NO.	DESCRIPTION	DATE
1	ISSUED FOR PERMIT	06-07-19
2	PERMIT / OWNER REV.	09-19-19
3	OWNER REVISION / VE	10-04-19
4	MARKETING & COORDINATION	11-05-19
5	PRECAST UNIT REVISIONS	02-03-20
6	ELEV. MANUF. UPDATES	03-19-20
7	TYPEK DETAILS - R1#1	05-08-20
8	EXTERIOR LIGHTING UPDATE	07-31-20
9	WALKROOM DETAILS	08-20-20
10	OWNER DEN ENCLOSURE	09-17-20
11	COMBO UNIT REVISION #1	10-09-20

A101.2

CASE #PL2020-227

1 FIRST FLOOR PLAN - EAST
SCALE: 1/8"=1'-0"

1 FIFTH FLOOR PLAN - EAST
SCALE: 1/8"=1'-0"

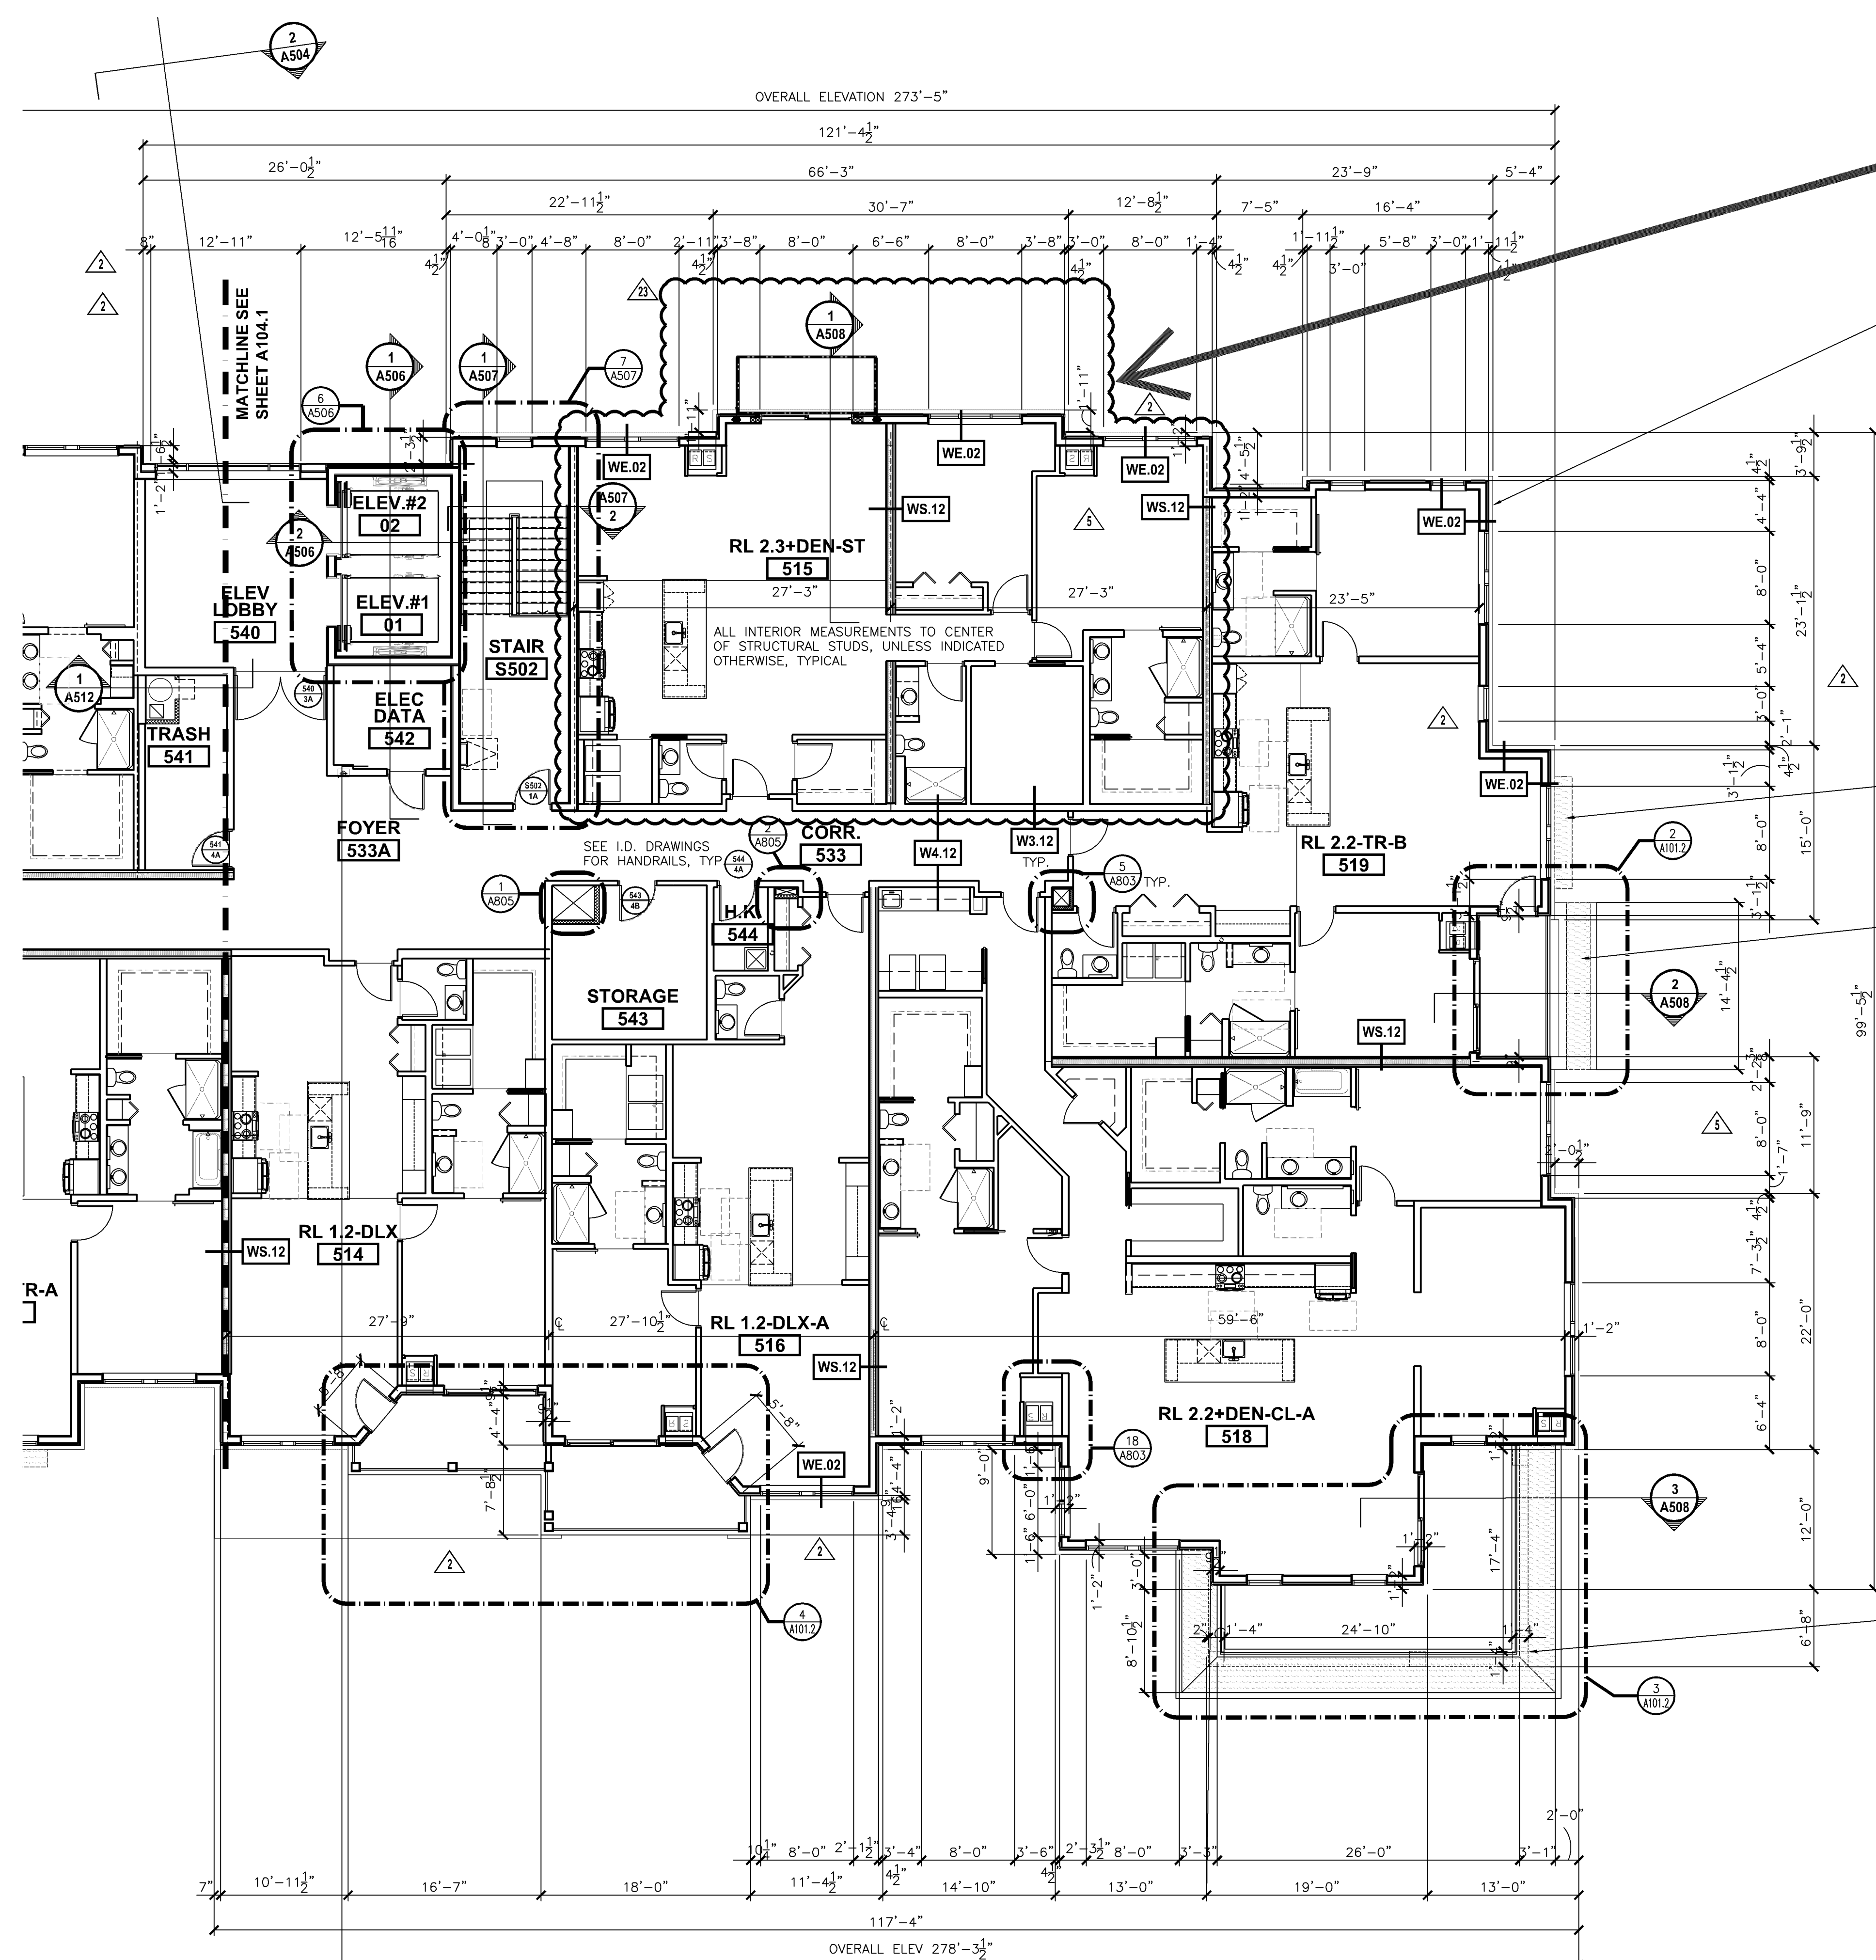
(1) ADDED BALCONY,
COMBINED (2) UNITS
INTO A SINGLE UNIT

1 ELEVATION
SCALE: 1/8\"/>

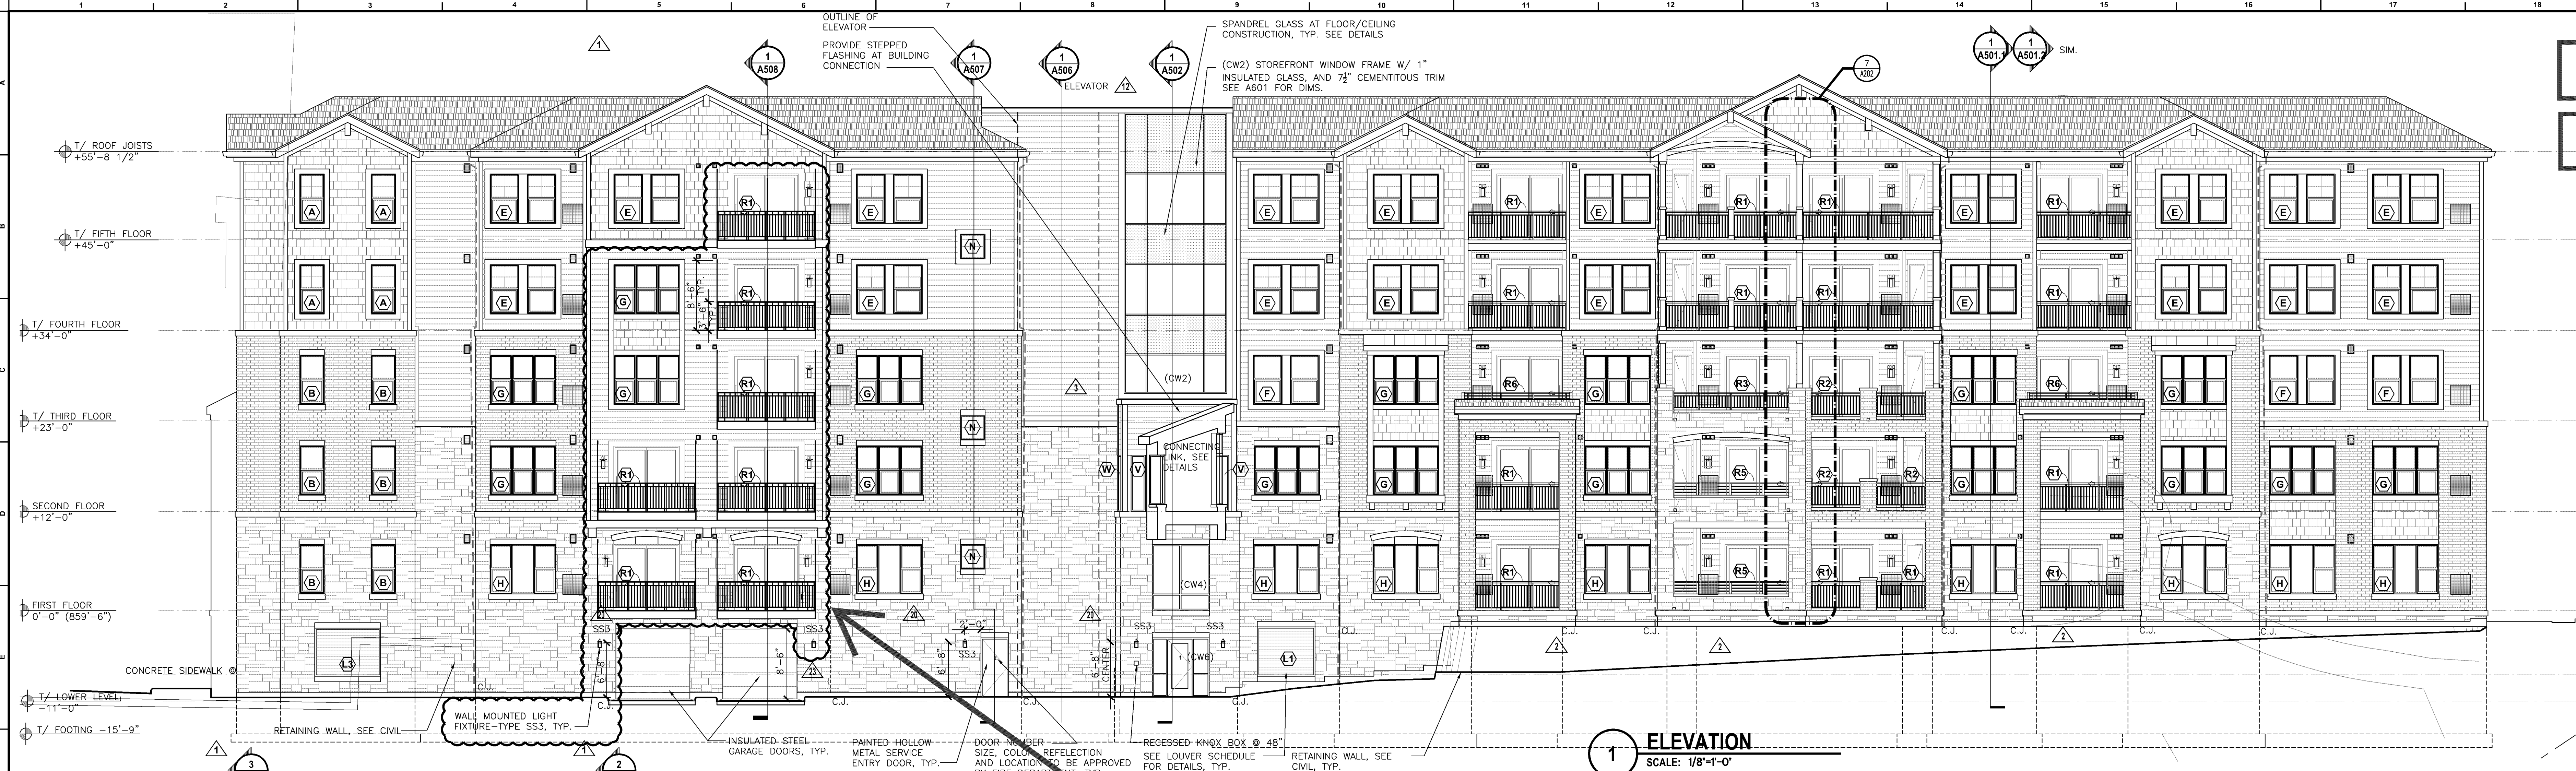
(7) ADDED BALCONIES
AT NORTH FACADE
